**Amendments to the Drawings:**

Appl. No. 09/844,840  
Amdt. Dated July 30, 2004  
Reply to Office action of April 30, 2004  
Replacement Sheet  
**APPENDIX**

Replacement Sheet for Figures 1 and 4

**FIG. 1**

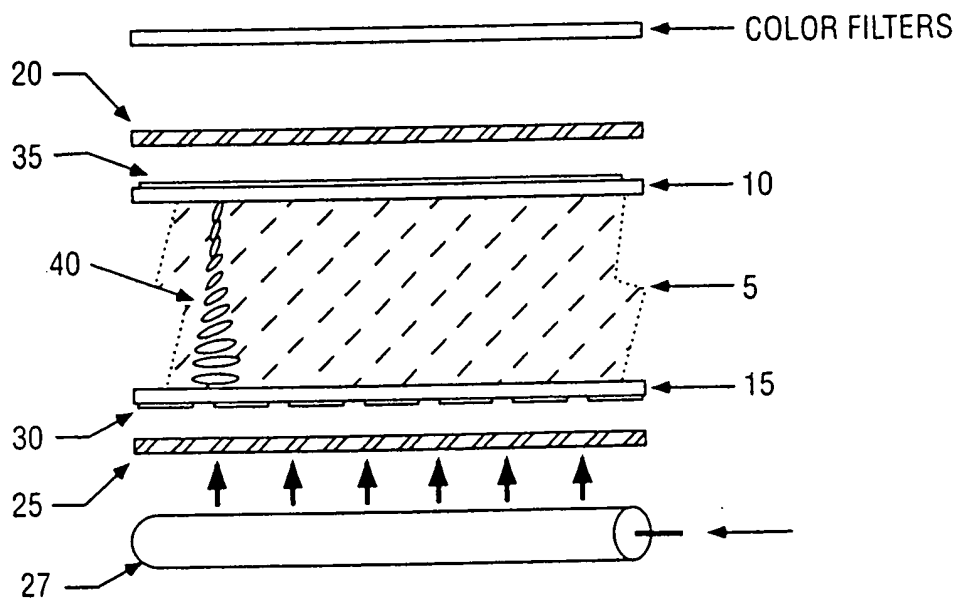
The attached sheets of drawings includes changes to Figs. 1 and 4. These sheets, which include Figs. 1 and 4, replace their corresponding original sheets. In Figure 1, previously omitted "Prior Art" legend has been added. For Figure 4, the synchronizer is shown with a "digital timer connected to the voltage controller" as requested by the Examiner. No new matter has been added.
